SERVICE PROCEDURE

19501

SUBJECT: SAFETY RECALL

Exhaust Hanger Bracket in certain 2016 thru 2020 International® LT® Series trucks built 15 December 2015 thru 08 February 2019 and certain 2017 and 2018 ProStar® model trucks built 02 March 2016 thru 12 June 2017 with 73-inch sleeper cab and feature code 07BKP or 07BKR (exhaust system with horizontal aftertreatment devise and horizontal tailpipe mounted on right-side).

Figure 2. Exhaust System

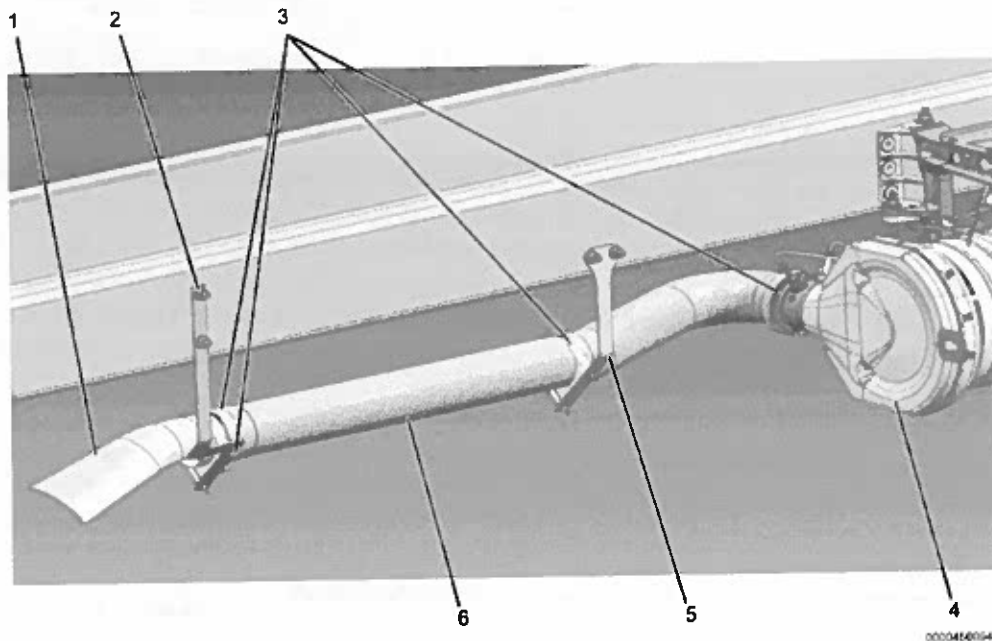
The rear exhaust hanger bracket may crack and, over time, may cause the forward hanger bracket to crack and in some cases may result in partial or full separation of the exhaust tail pipe from the vehicle. If the exhaust tail pipe separates from the vehicle in operation, a loose part in the roadway could be struck by another vehicle which increases the risk of a vehicle crash.

5. Inspect exhaust tailpipe (Figure 2, Item 6) at Diesel Particulate Filter (DPF) (Figure 2, Item 4) for cracks.
 - a. If exhaust tailpipe has no cracks, proceed to Step 10.
 - b. If exhaust tailpipe has cracks, continue with Step 6.
6. Disconnect exhaust tailpipe from DPF and from rear hanger bracket (Figure 2, Item 2) and forward hanger bracket (Figure 2, Item 5). Save DPF clamp and clamp used at forward hanger bracket for reuse.
7. Remove diffuser (Figure 2, Item 1) from exhaust tailpipe. Save diffuser and clamp (Figure 2, Item 3) for reuse.

8. Using Marmon clamp or band clamp (Figure 2, Item 3), install diffuser (Figure 2, Item 1) onto new exhaust tailpipe (Figure 2, Item 4). Tighten Marmon clamp or band clamp to their specified torque.

9. Install new exhaust tailpipe (Figure 2, Item 6) onto DPF (Figure 2, Item 4). Do not tighten clamp at DPF (Figure 2, Item 3) at this time.
10. Remove rear hanger bracket (Figure 2, Item 2) from frame and save fasteners for reuse.

11. Remove clamp (Figure 2, Item 3) and rear hanger bracket (Figure 2, Item 2) at diffuser (Figure 1, Item 1) and discard.
12. Install new rear hanger bracket (Figure 2, Item 2) to frame. Tighten fasteners to 148 lb-ft (200 N.m).

13. Install new clamp (Figure 2, Item 3) and rear hanger bracket (Figure 2, Item 2) at diffuser (Figure 1, Item 1). Do not tighten clamp at this time.
14. Inspect forward hanger bracket (Figure 2, Item 5) for cracks.

- a. If bracket has no cracks, proceed to Step 19.
 - b. If bracket has cracks, continue with Step 15.
15. Remove forward hanger bracket (Figure 2, Item 5) from frame and save fasteners for reuse.

17. Install new forward hanger bracket (Figure 2, Item 5) to frame. Tighten fasteners to 148 lb-ft (200 N•m).
18. Reinstall clamp (Figure 2, Item 3) around exhaust tailpipe at forward hanger bracket (Figure 2, Item 5). Do not tighten clamp at this time.
19. Tighten clamps (Figure 2, Item 3) at forward hanger bracket (Figure 2, Item 5) and rear hanger bracket (Figure 2, Item 2). Tighten both clamps to 195 - 247 lb-in (22 - 28 N•m).
20. If pipe was replaced, tighten clamp at DPF (Figure 2, Item 3) to 89 – 133 lb-in (10 - 15 N•m).
21. Remove wheel chocks.
